MINUTES FROM 19 JANUARY 1995 BASE REALIGNMENT AND CLOSURE TEAM MEETING  
NTC ORLANDO FL  
1/19/1995  
ABB ENVIRONMENTAL

**Subject:** Minutes of BCT Meeting, January 12 & 13, 1995

#### Operable Unit 1 Work Plan

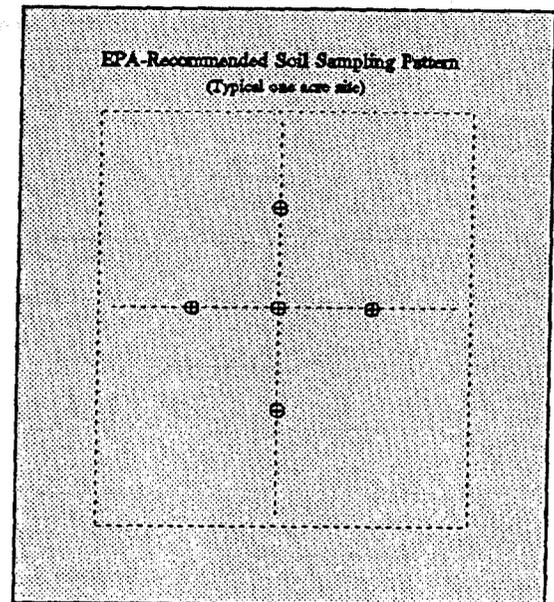
With regard to surface soil sampling of landfill cover, Craig Brown commented that one soil sample per acre is acceptable; however, EPA's definition of one sample is a composite of five samples collected on a pattern in the centroid of each one-acre square on the grid (see figure at right). Typically, the VOC sample would be collected as a grab sample from the central point, prior to compositing. He said that EPA is not firm on the compositing and may be willing to accept a single point. Whichever method is selected, VOC samples cannot be composited. ABB agreed to composite samples in accordance with EPA's preference.
